TRANS/WP.29/2004/55
11 August 2004

PROPOSAL FOR DRAFT SUPPLEMENT 3 TO REGULATION No. 113

(Headlamps emitting a symmetrical passing beam)

Transmitted by the Working Party on Lighting and Light-Signalling (GRE)

"Annex 8

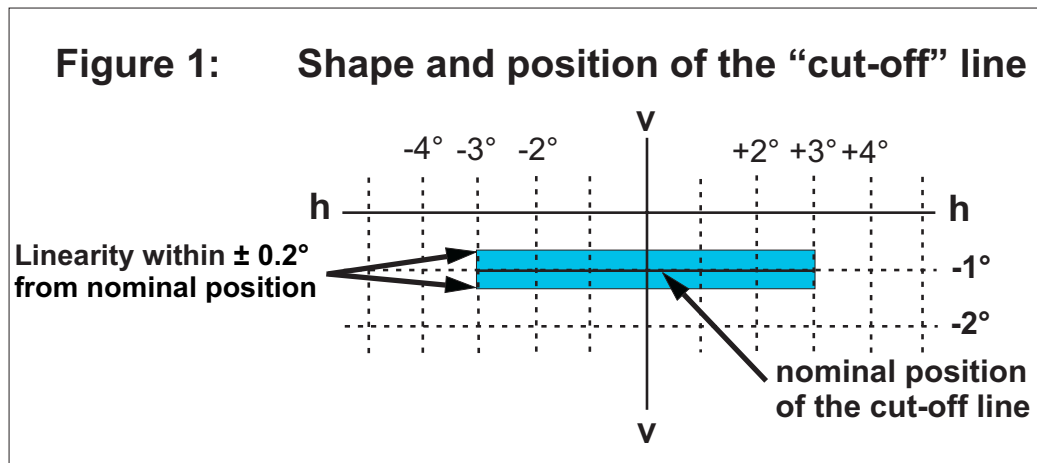
2.1. For visual adjustment of the symmetrical passing-beam headlamp the cut-off line shall provide: a horizontal line for vertical adjustment of the symmetrical passing-beam headlamp extending to either side of the v-v-line (see Figure 1) as specified in paragraph 6.2.1. of this Regulation.

If the horizontal part is not straight but slightly curved or inclined, the cut-off line shall not exceed the vertical range formed by two horizontal lines which are situated from 3° left to 3° right of the v-v-line at 0.2° for class B and 0.3° for class A, C and D head lamps above and below the nominal position of the cut-off (see Figure 1).
